## ARCHITECTURAL REVIEW BOARD WORK SESSION AGENDA

**Agenda Item:** APPLICATION FOR ALTERATION TO AN EXISTING STRUCTURE, ARB #26-003, 500 Carlisle Drive, Herndon, Virginia, to consider an application for the erection of exterior equipment screening walls at the property located at located in the eastern side of Carlisle Drive, south of the intersection with Elden Street

This staff memo relates to the proposed Special Exception (SE#25-02) at the property at 250 Spring Street, located north of Spring Street between its intersections with Springpark Place and Herndon Parkway. The site is approximately 4.17 acres in area and features an 87,130 square foot self-storage facility (*Figure 1*). The proposed design expands the self-storage space to a total of 126,775 square feet, with 60,175 square feet of new construction. About 66,600 square feet of the existing self-storage buildings will remain. The site is in the Office and Light Industrial (O&LI) zoning district. This item is continued from the April 1, 2026, ARB work session agenda.

*Figure 5: Examples of other ExtraSpace Storage facility designs with masonry cladding and detailing. Left: 1046 Richard D Sailors Pkwy, Powder Springs, GA; Right: 3805 Powder Springs Rd, Powder Springs, GA.*

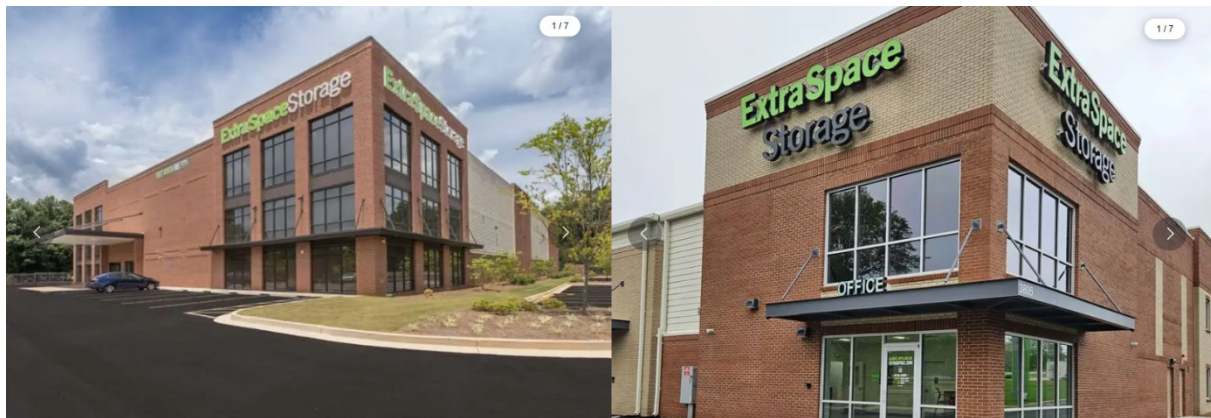
*Conformance to Accepted Architectural Principles (Criterion 5):* The proposed design is largely consistent with the massing and overall façade articulation and hierarchy of other ExtraSpace Storage designs that employ brick on the façade (*Figure 5*). However, the articulation of the fenestration appears to be better resolved in the finished examples from elsewhere than it is depicted in the renderings for the proposed design at 250 Spring Street, particularly as seen on the façade (south elevation). The ARB should discuss expectations for appropriate detailing and overall articulation for the fenestration of the proposed design.

**1 WEST ELEVATION**  
SCALE: 1/8" = 1'-0"

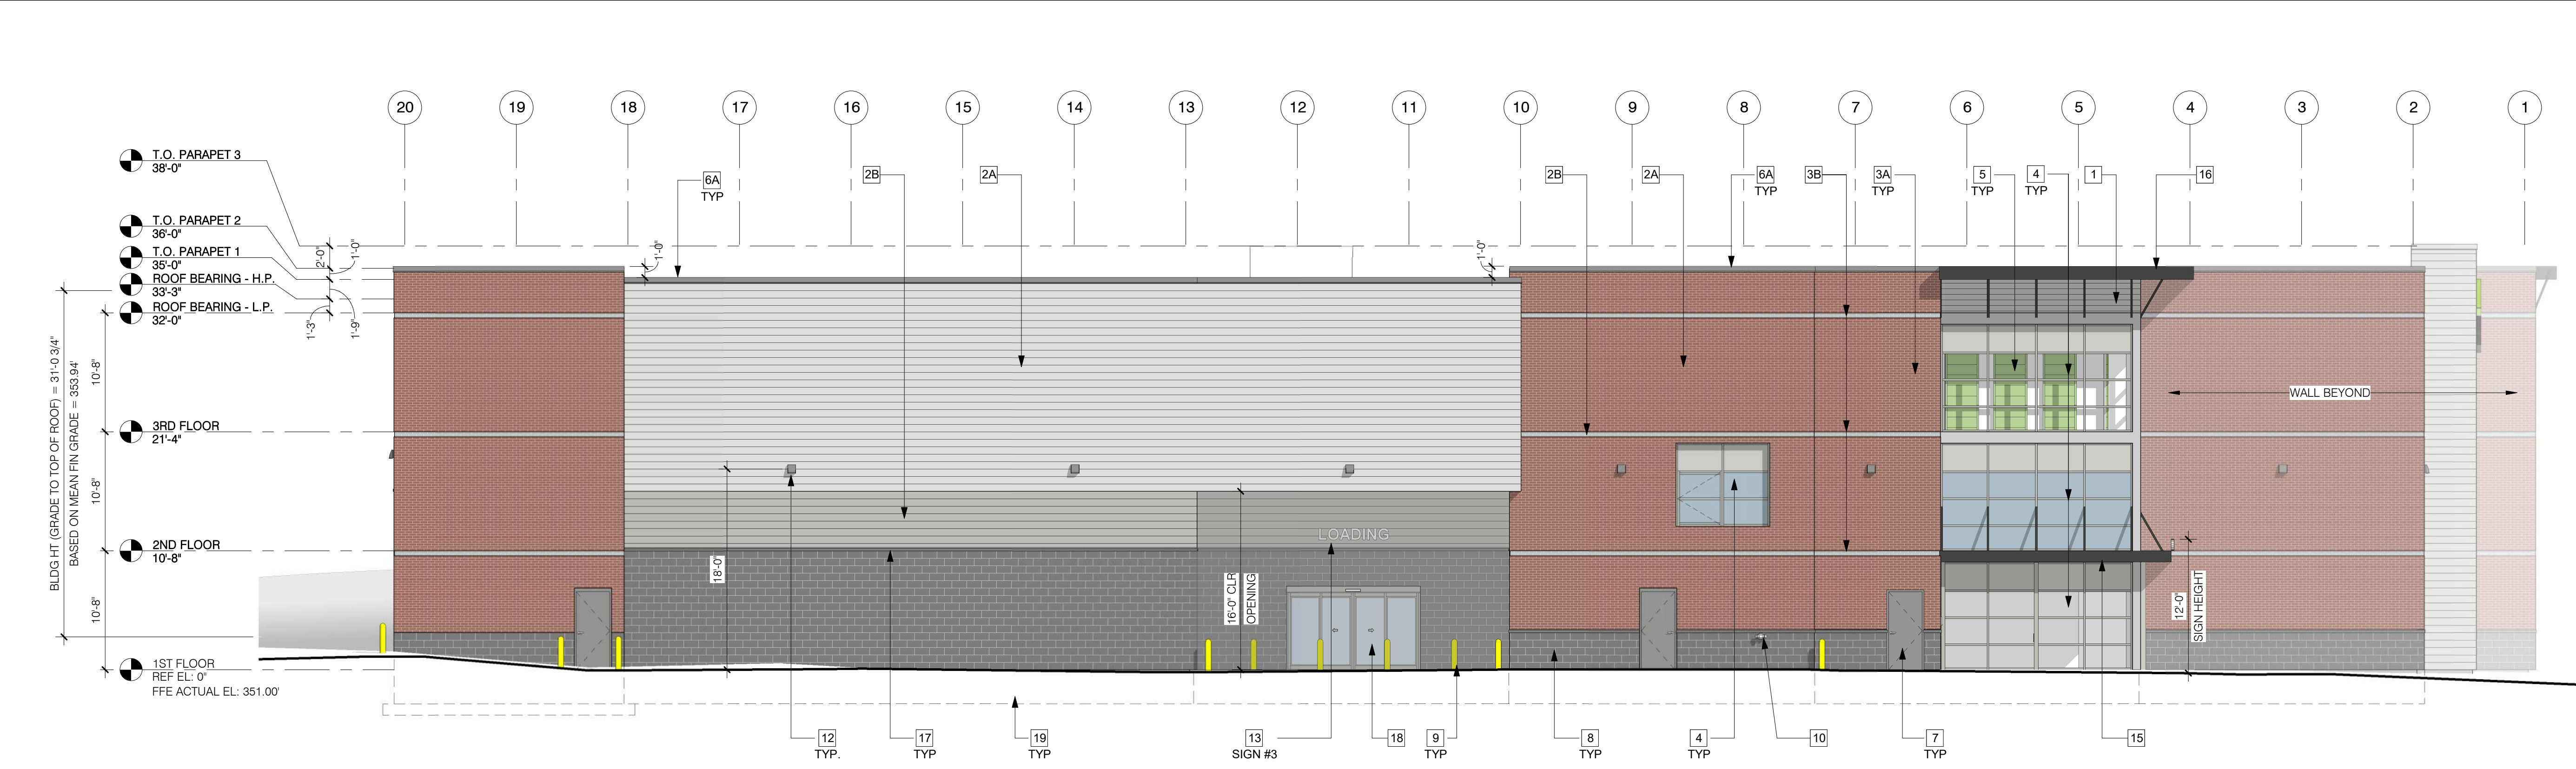
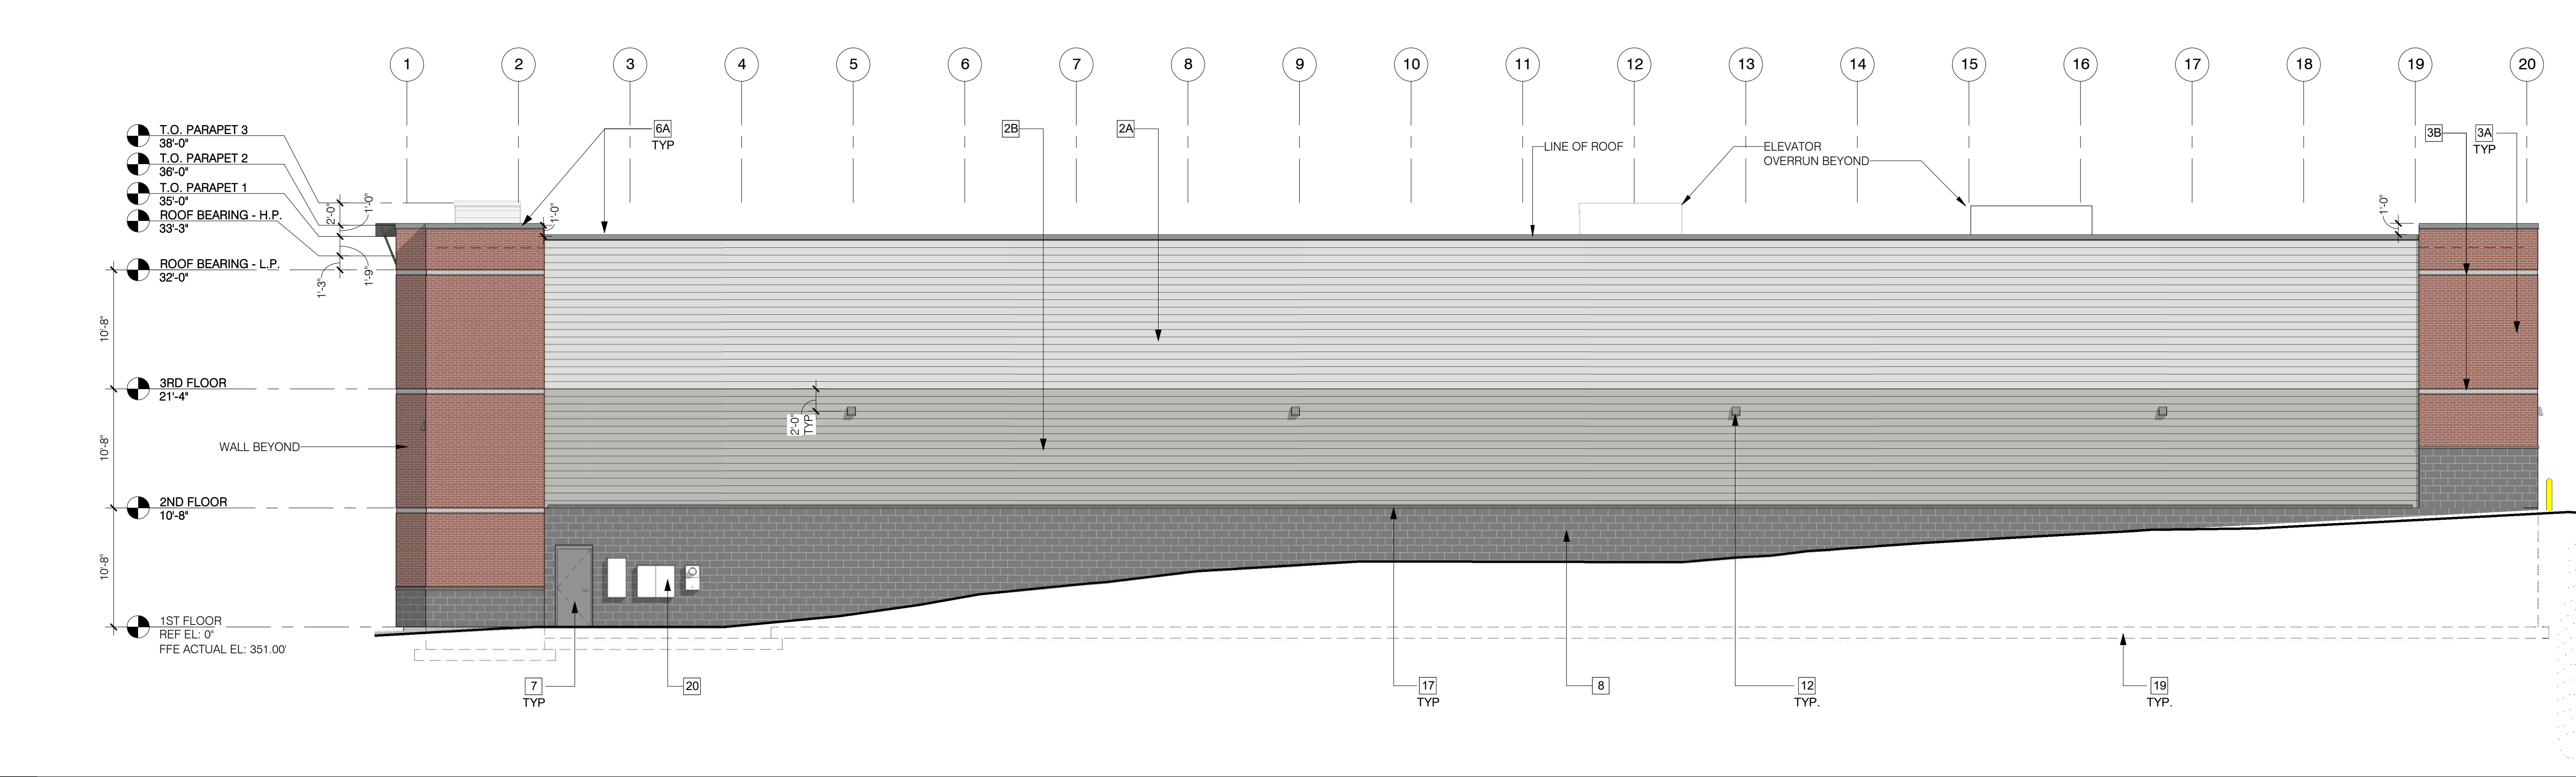
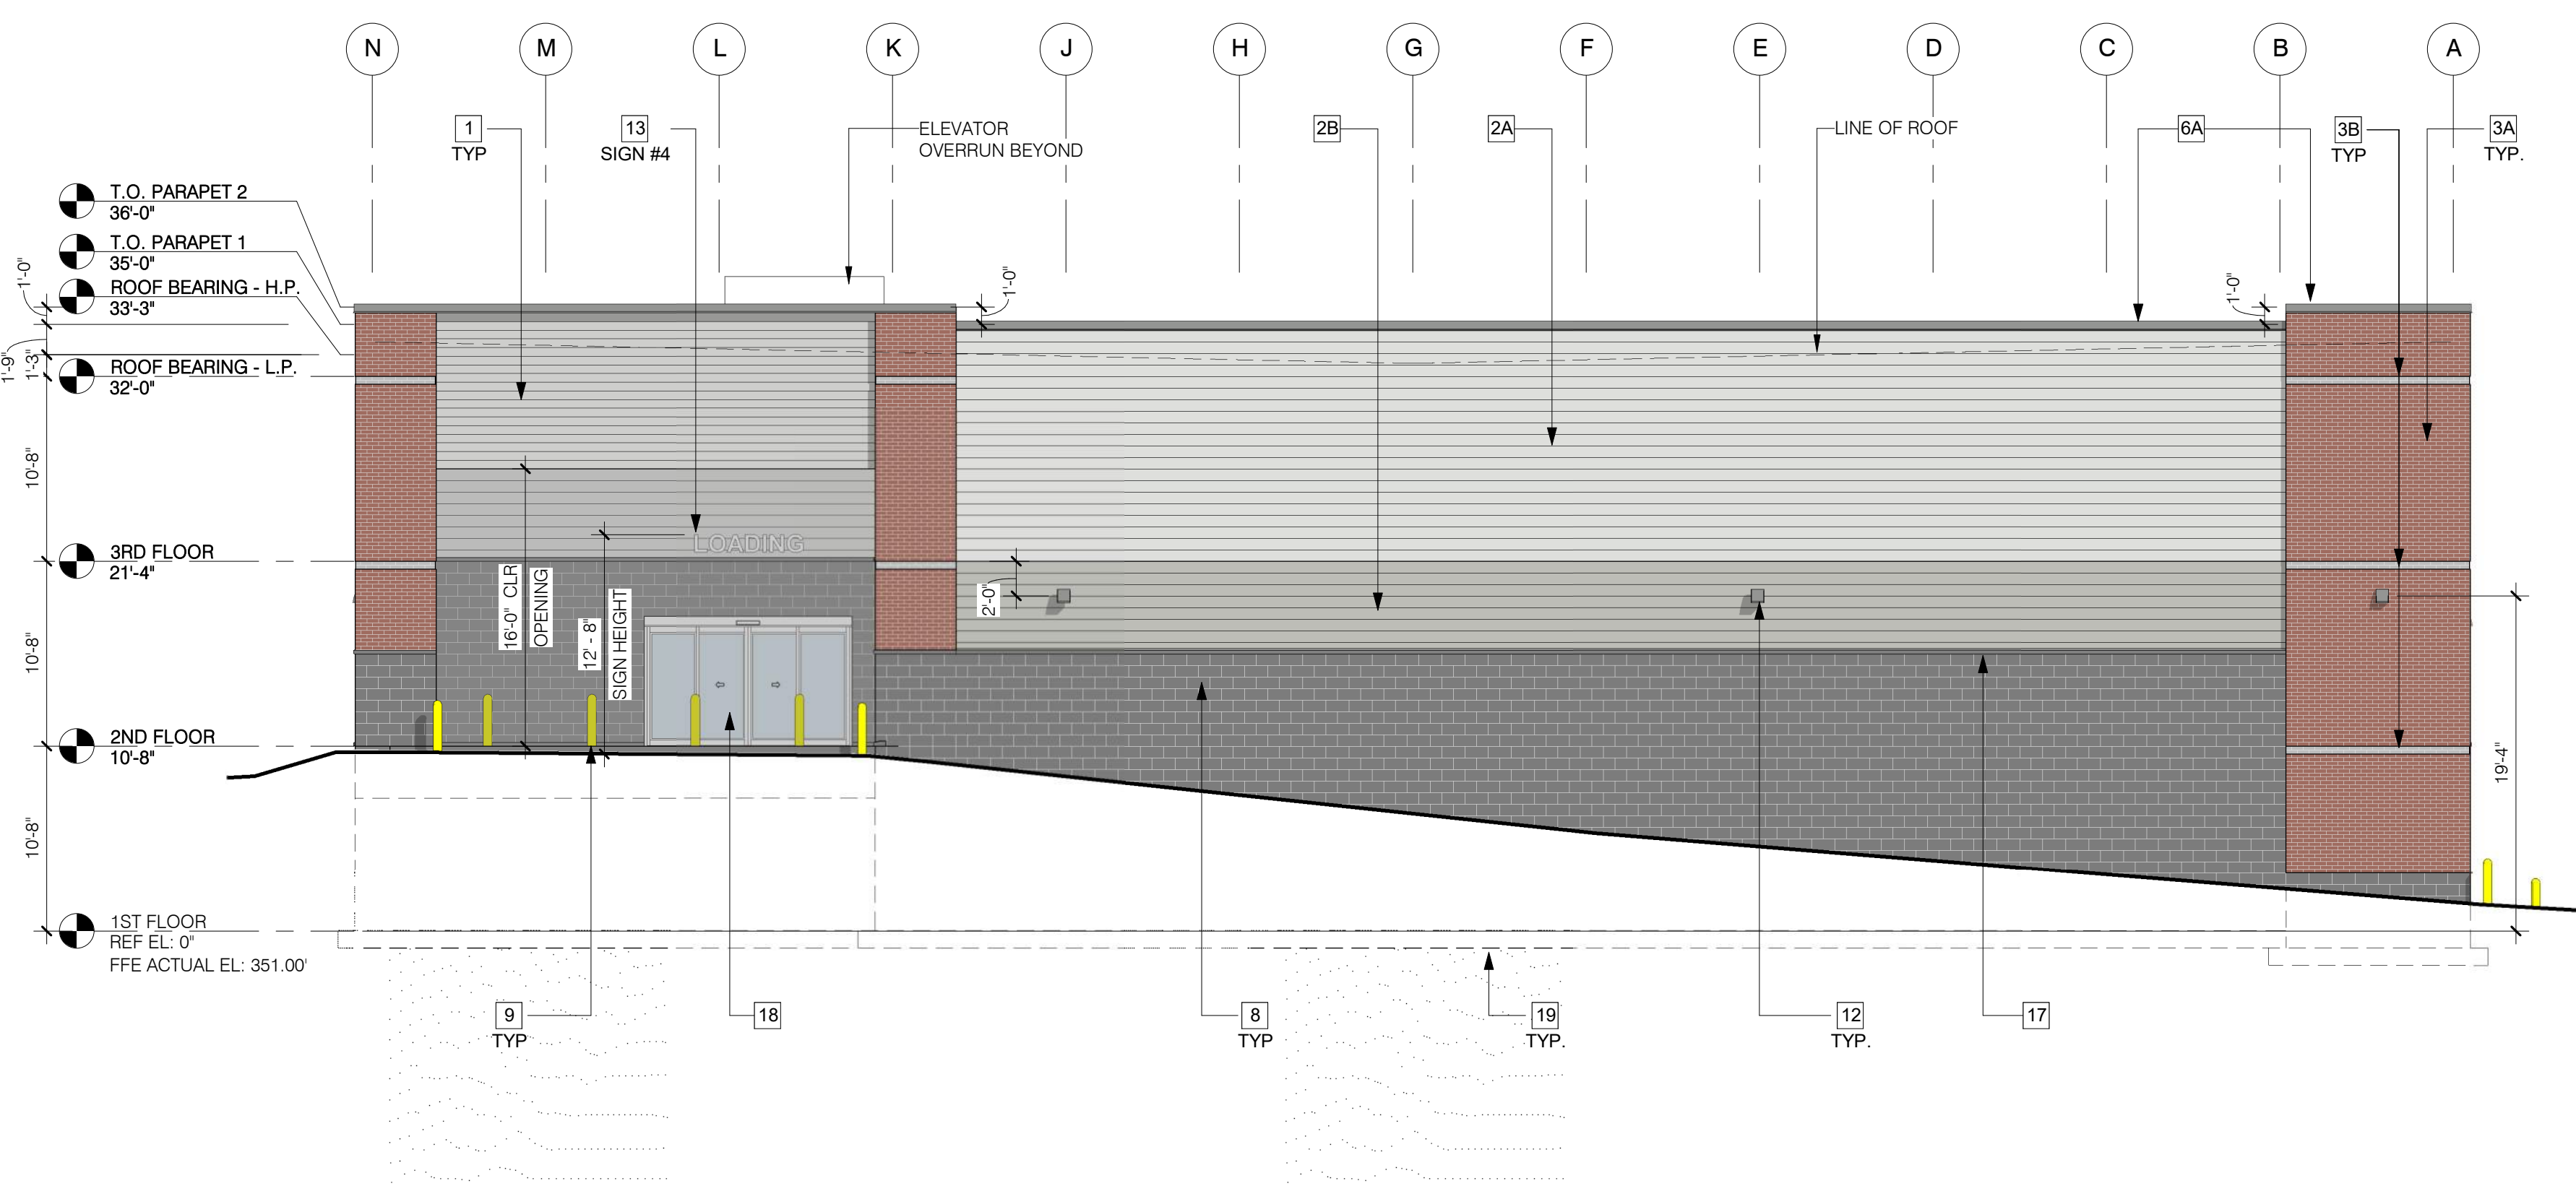
The division of bays on the façade (south elevation) and the west elevation, both highly visible from the right-of-way, establishes a hierarchy between bays and presents a mostly cohesive design. Additional details will be needed to fully understand the articulation of the fenestration on the storefront at the southwest corner, as well as the bay of windows on the façade. Currently, the view of the façade rendered from the southeast corner appears to lack dimensionality in its articulation, but this may be due to the rendering itself rather than the intended design (*Figure 2*). The board should discuss if the notable difference in the overall detailing on the north and east elevations is appropriate given the limited visibility from the right-of-way. Furthermore, the materials provided do not contain information on the size or arrangement of the accompanying self-storage buildings behind the main office. The applicant should provide the board with a plan that shows their arrangement, as well as elevations for a typical building unit's design.

*Architectural Harmony (Criterion 4):* As discussed above, the two most public facing elevations (south and west) are extensively clad in masonry and the articulation and hierarchy of the massing along each elevation is highly resolved. In contrast, the east and north elevations feature large expanses of metal siding and do not have much articulation or hierarchy to break up the wall plane. These elevations have limited visibility from the right-of-way. The ARB should discuss whether this conforms to Criterion 4, which looks to ensure that the treatments for exterior walls of freestanding buildings are harmonious.

*Architectural and Aesthetic Acceptability (Criterion 6):* ACD Criterion 6 is partly concerned with whether or not a proposed design for a commercial building could be construed as an advertisement or a commercial display. The design as proposed refrains from using a color palette that is associated with the brand identity of ExtraSpace Storage, although gray is included in some of the masonry and metal siding detailing and the green of the interior will be partially visible from outside the building. Staff is of the opinion that these details are balanced with the prominent use of red brick and off-white siding on all elevations. The previous design proposal for this property submitted as part of the associated Special Exception employed the branded identity of ExtraSpace Storage to a greater extent than the current design (*Figure 6*; sheets A401-A404 of the May 6 meeting materials). The ARB should discuss whether the updated

Additionally, the use of large swaths of unadorned walls, though largely reflective of the building function, should be assessed for appropriateness and whether additional fenestration or decorative treatments should be employed to add visual interest, manage the scale, and more consistently carry through lines and patterns across the various divergent designs bay-to-bay.
